Agenda - Executive Policy Committee - March 14, 2007

Item No. 1 Access to a proposed commercial development located on the west side of Kenaston Boulevard
File SC-1(31)

RE: ACCESS TO A PROPOSED COMMERCIAL DEVELOPMENT LOCATED ON THE WEST SIDE OF KENASTON BOULEVARD (c/o TUXEDO BUSINESS PARK INC., 1 TERRACON PLACE, WINNPEG, MANITOBA R2J 4B3, ATTENTION: MR. MICHAEL FALK)

Date:	November 23, 2006
File:	**SAA 9/06**
Related Files:	N/A
Subject:	To amend the subdivision agreement under **DASSF 539/99** to amend paragraph 3 by adding; ***"iv) off the public right-of-way onto Lot 2, Plan 39119."***
Location:	1303 Kenaston Boulevard
Legal Description:	Lot 2, Plan 39113
Applicant:	Tuxedo Business Park Inc. (Mr. Michael Falk)
Owner:	Terracon Development Ltd.
Recommendation:	**Denial**

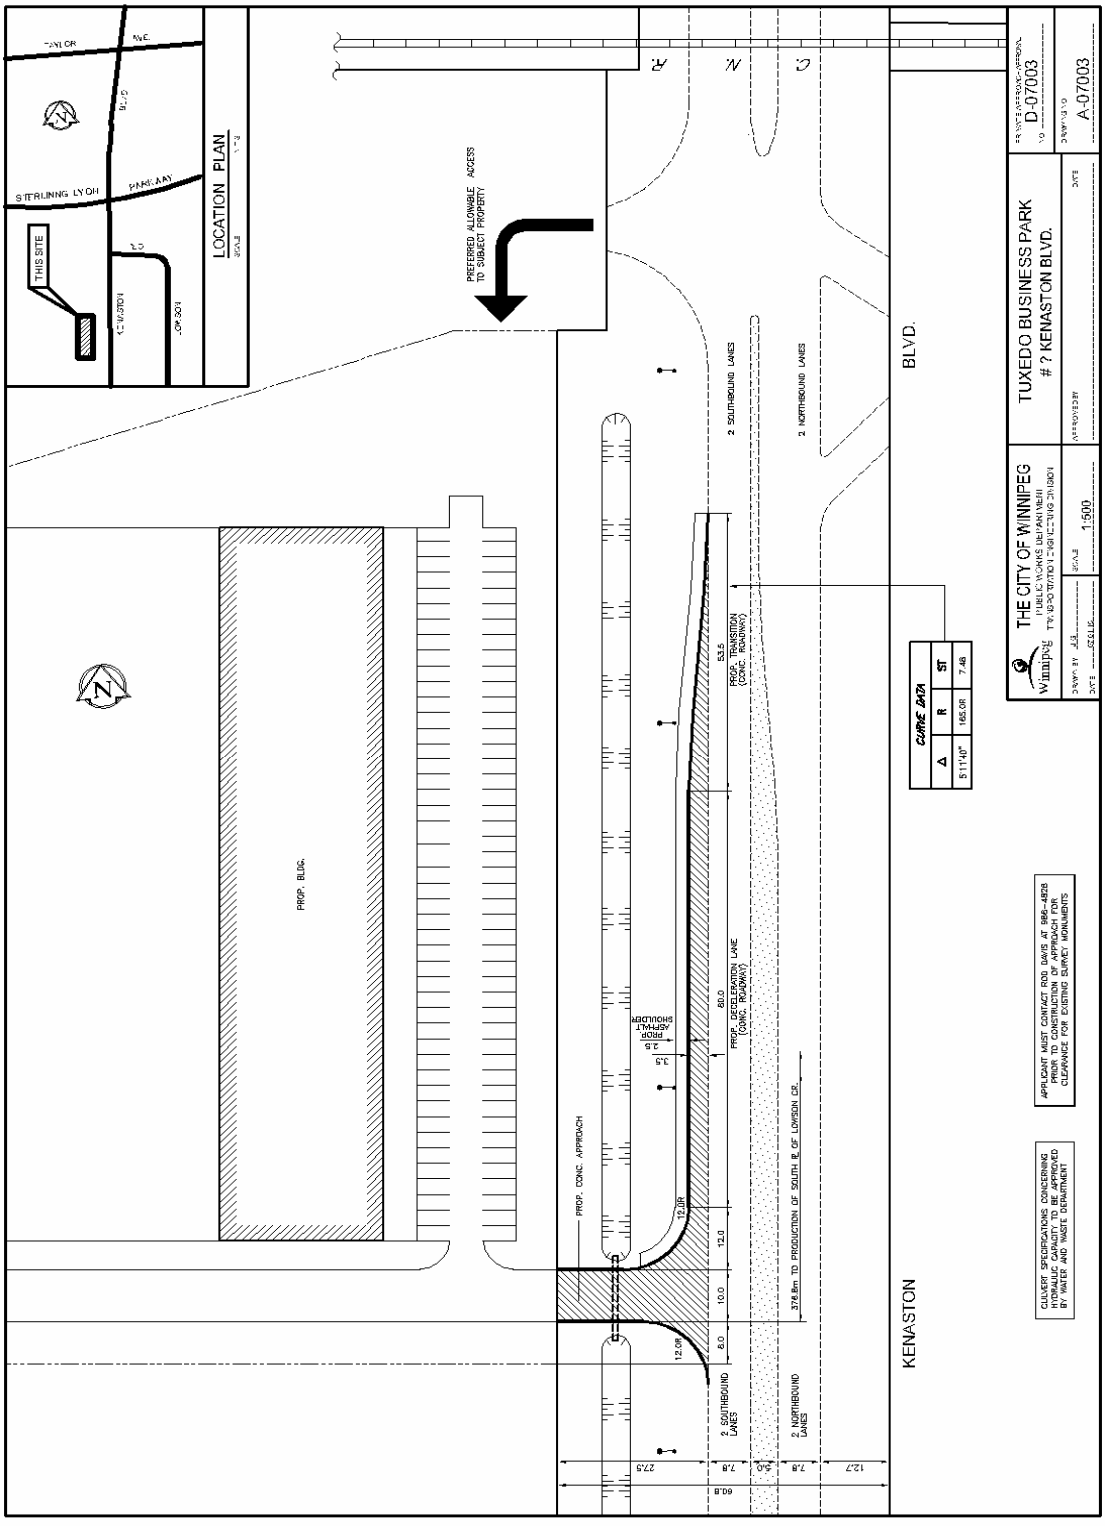
1. That the construction of 1-10.0 metre private approach on the west side of Kenaston Boulevard approximately 376.8 metres south of Lowson Crescent (as shown on Drawing No. A-07003) *not* be approved.

The proposed private approach (as shown on Drawing No. A-07003) is not permitted by the Private Approaches by-law No. 6546/95. This Department does not recommend approval for this proposed approach from Kenaston Boulevard, and recommends that all access to the proposed development to be from the adjoining property to the north.

This Department recommends that no access on the west side of Kenaston Boulevard be approved for the following reasons:

1. This section of Kenaston Boulevard is contained within Schedule 1 of the Private Approaches By-law for reasons of traffic operations, capacity and safety. Vehicle collisions and capacity of a street are directly related to the number of approaches to private property from a street; as the number of approaches increase the number of potential vehicle conflicts also increase thereby reducing the capacity of the street and increasing the potential for vehicle collisions. Major arterial streets such as Kenaston Boulevard are intended for the transportation of large volumes of through traffic at relatively high speeds; private approaches diminish the capacity of and level of motorist safety on those streets.

2. The proposed development can be safely and conveniently accommodated with all access from the adjoining property to the north.

3. This Department has restricted access to other developers with property on Kenaston Boulevard for the same reasons. If the Committee approves access for this development, a precedent will be set.

For the above reasons the Public Works Department strongly recommends against permitting any access to the proposed development from Kenaston Boulevard, and recommends that all access to the proposed development to be from the adjoining property to the north.

2. If it is the Committee's decision to approve access to Kenaston Boulevard, the Public Works Department recommends that it be approved as shown on Drawing No. A-07003, subject to the applicant paying all costs for the approved bi-directional approach and associated work, including a deceleration lane with transition; and with the understanding that no median opening within Kenaston Boulevard be approved.

Figure 1: Subject Site; i), ii) & iii) indicate the approved approaches in the existing Subdivision Agreement (Aerial Flown 2005)

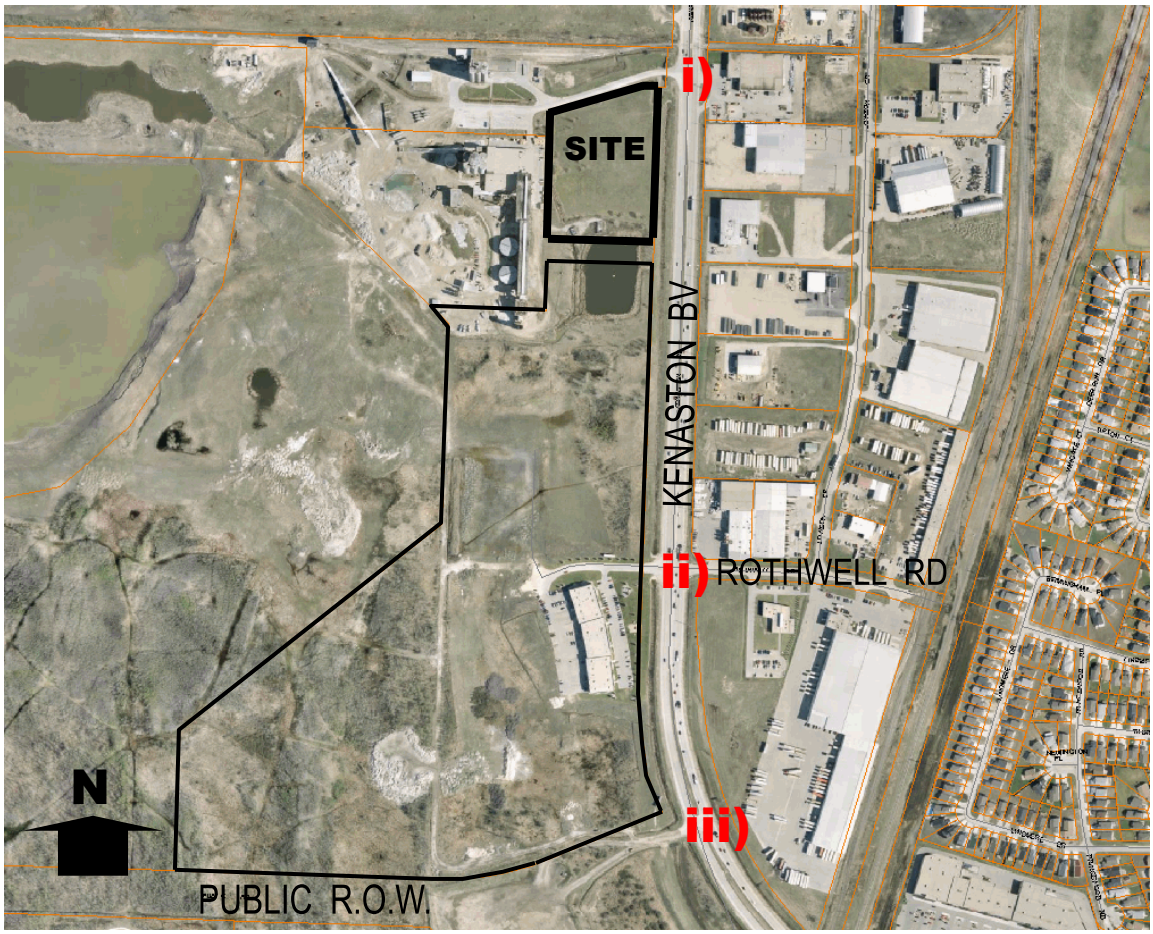
The Planning and Land Use Division does not support this application to amend the Subdivision Agreement. The subdivision was intentionally restricted to a maximum of three approaches based on the development review by the Administrative Coordinating Group. Kenaston Boulevard is a major arterial with a by-law restricting private approaches due to concerns regarding public safety and efficiency.

Presently, access to the Tuxedo Business Park is available at the signalized approach opposite Rothwell Road, (number ii) in the agreement). They also had access off of the existing Lehigh Cement approach for which they were required to have a cross access agreement in place with Lehigh Cement. The applicant has indicated that Lehigh Cement has now blocked that access and they are involved in litigation to rectify the situation.

- That it is contrary to the private approaches By-law restricting additional private approaches onto Kenaston Boulevard,
- The development has three approved approaches off Kenaston Boulevard as per previous agreement,
- We believe that there are other alternatives that will allow the planned development to proceed without the potential negative impact a new approach will have on the safety and efficiency of Kenaston Boulevard.

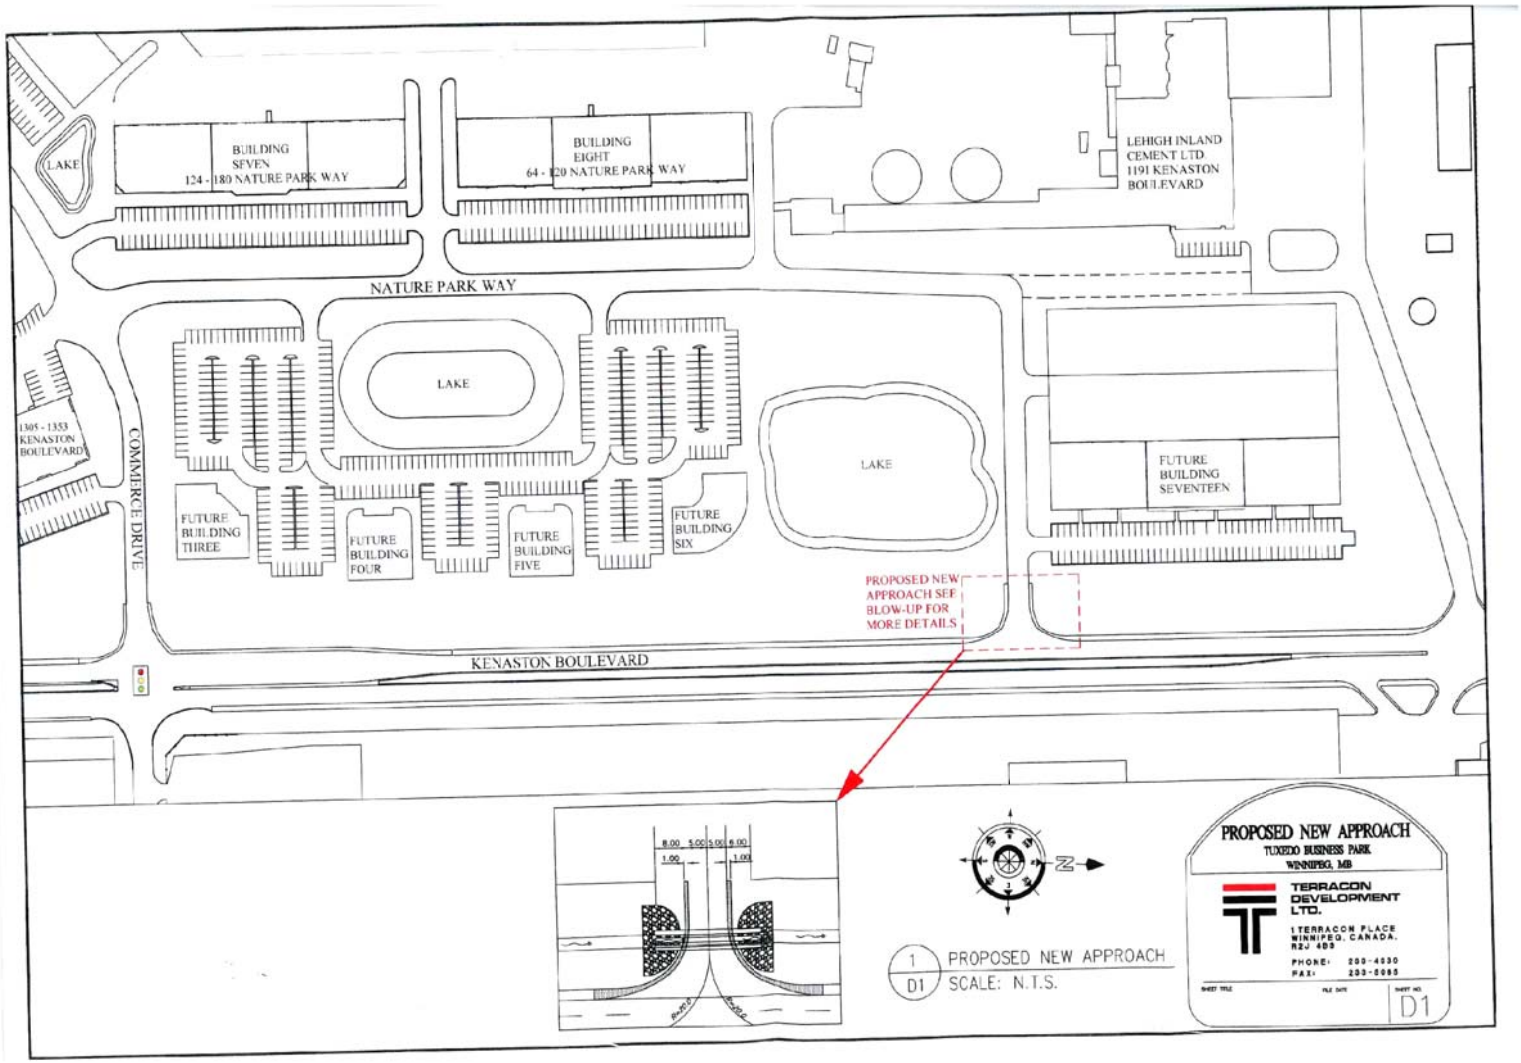
2. That the Private Approaches By-law No. 6546/95 be amended to permit a private approach off the public right-of-way, known as Kenaston Boulevard onto Lot 2, Plan 39119, as a right in and a right out" in accordance with the plan submitted by Terracon Development Ltd. and identified as Sheet D1,
